Bulletin No.: 060131-1
Release Date: January 31, 2006
Effective Date January 31, 2006
Supercedes: None
Completion Date: As Necessary
Page 1 of 1

SERVICE BULLETIN

Ride Manufacturer: Eli Bridge Company
Ride Names: All BIG ELI[®] Aluminum Wheel Seats

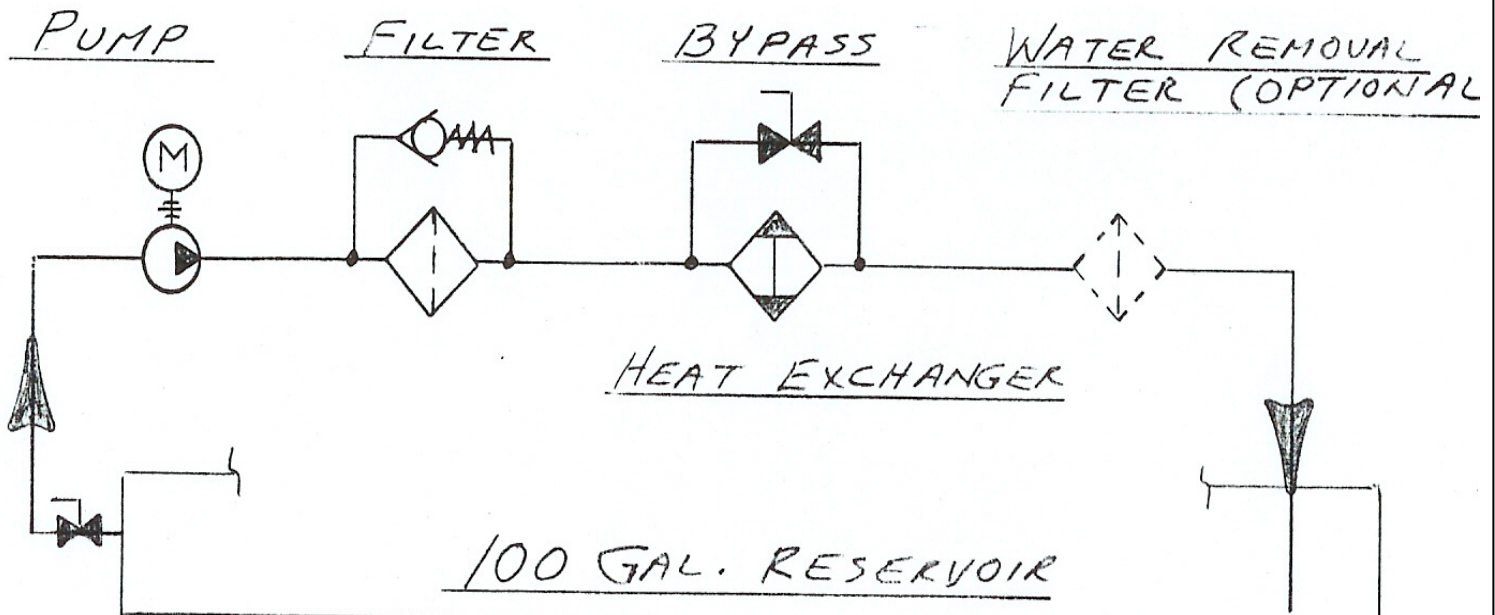
Due to various factors which include loading, high ambient summer heat, duration of operation, and efficiency of hydraulic components available several years ago, some hydraulic driven Wheels have experienced excessive oil temperatures. Therefore, Eli Bridge has developed a hydraulic oil cooling and continuous filtration system to add to your reservoir for long term protection.

To insure the best component life and long term reliability, the system oil should be maintained to proper temperature (about 140 degree maximum) and cleanliness (40-micron minimum, 10-micron preferable). The easiest and least expensive way to accomplish this is to install a filtration-cooling loop across the reservoir. This consists of a gear pump, filter assembly, and an oil to air cooler arranged to constantly cool and filter the reservoir oil. The cooler has a bypass valve to allow filtering the oil without removing heat on cooler days.

If your Eli Bridge Wheel has experienced overheating, install Eli Bridge Company's filter/cooler package on your hydraulic reservoir. The system schematic is shown below. The reservoir is approximately 100-gallon capacity, therefore the oil is filtered and cooled continuously and turned over about every 4 minutes. For high condensation problems, a water removal filter can also be installed in the loop.

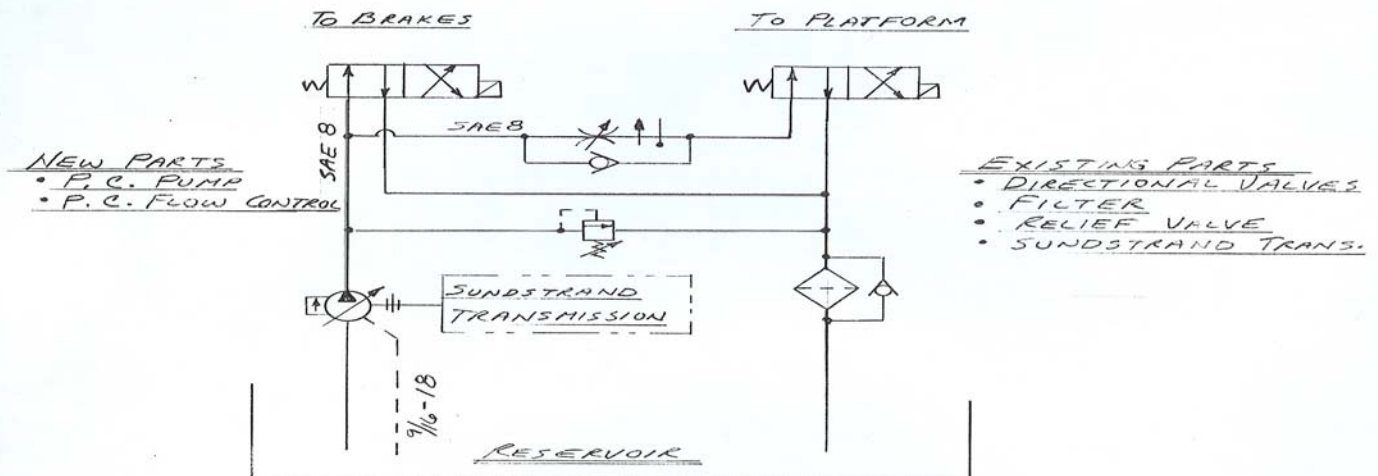
Abstract of Issue: The hydraulic rim-drive Wheels were designed around available components of the 70's through 90's which were functional but not necessarily as efficient as modern day hydraulic components. Safety was and still is a primary concern. The present brake and platform circuits create heat, which on a hot day can be excessive for the system to absorb. Too much heat can be detrimental to the long-term function of the hydraulic components. Eli Bridge Company has developed a more energy efficient circuit upgrade for the brake/ platform functions.

Reason For Release: The present circuit design for the hydraulic brakes and platform are inefficient using more parts than necessary and presently creating most of the heat load in the circuit. These systems are very important safety issues of the ride and must function flawlessly. There are several ways of reducing the heat generated in these circuits but brake pressure must be held at all times. Therefore the best circuit revision will be to replace the existing brake gear pump with a pressure compensated pump used for the brake and platform circuit. By limiting the flow to the platform cylinder to less than full pump flow, we maintain constant brake pressure. The heat generated by this circuit is about 1/4 of the present heat load. Another major benefit to this revision is the elimination of the separate power unit for the platform circuit. The new pump is driven off the main 30 HP drive which now will be the only power unit required for the Aristocrat. The Eagle has a separate power unit for setup, which could be eliminated by using oil from the new pump, but because the required pressures are so different, it is advisable to maintain the setup circuit as is and shut this unit off after setup.

Action to be taken: Replace the auxiliary brake gear pump with the new pressure compensated pump, remove the separate platform pump and motor, and tie these two circuits together as proposed by the Eli Bridge Co. circuit upgrade.

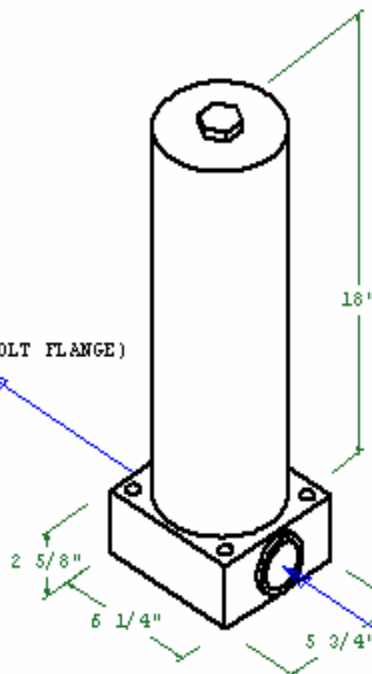
Abstract of Issue: New Option for prolonging the life of Sundstrand Hydrostatic transmissions is available for BIG ELI[®] Eagles and Hydraulic Rim Drive Aristocrat Wheels.

Reason for Release: The hydrostatic transmission (The Sundstrand #90L100) unit is the most important and expensive part of the hydraulic drive system. **To prolong the life of the unit**, a pressure filter in the closed loop circuit can now protect it. The Wheel drives forward about 80% of the time so the most cost effective and beneficial location of a filter would be on the return side of the closed loop in the forward mode. Eli Bridge Company offers a filter upgrade unit that can be installed between the return line of the wheel drive motors and the transmission "B" port.

Action to be taken: Install a pressure filter designed for hydrostatic transmission use on the return side of the closed loop in the forward mode to insure long and trouble free service for the owner. This will filter all oil before it returns to the transmission while running in the forward direction and through a reverse free flow check valve when running in reverse. The filter element is a 10-micron unit capable of holding a large capacity of 108 grams dirt. The housing has a pointer indicator to show the condition of the filter. Port size will be SAE-24 straight threads for O-ring seals for the most leak free installation. Call the factory for pricing and availability.

OUTLET TO SUNDSTRAND
RETURN PORT IN FORWARD
DIRECTION (PUMP PORT
1.00- 6000 PSI FOUR BOLT FLANGE)

INLET FROM WHEEL
DRIVE MOTORS
(PORT SIZE SAE-24)
